Shanta Expression Limited (Extention)

Structural Inspection Report

Production & Utility Building,

Observation 01: Marginally stress above normal design limit in column and foundation (Production & Utility Building).

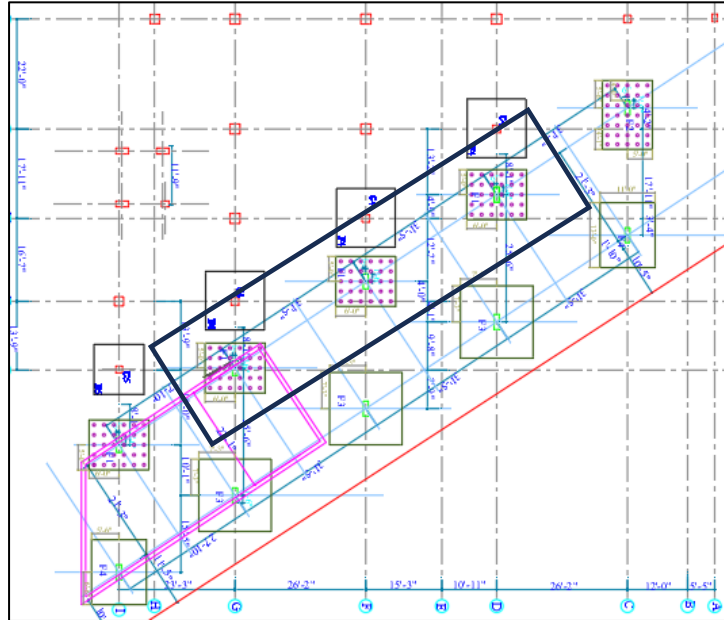
Description: Cursors calculation indicates that stress in the columns and foundation exceeds the normal design limit in the highlighted columns and foundation (marked in the layout) for the 7-storied structure.

Building engineer is required to perform in-situ material strength, review the design of the foundation stress and prepare a Detail Engineering Assessment (DEA) report with a proper remediation plan and submit to RSC for review.

Observation 02: Lack of Lateral Stability (Production & Utility Building).

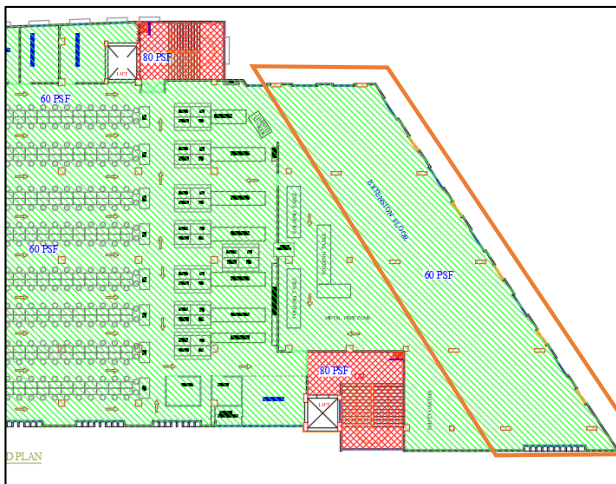
Description: This structure is a 7 storied structure with a single bay and the width of this building is very less compared to its length.

The building engineer is required to check the stability of this structure against lateral forces, stresses and serviceability's as part of DEA and submit to RSC for review.
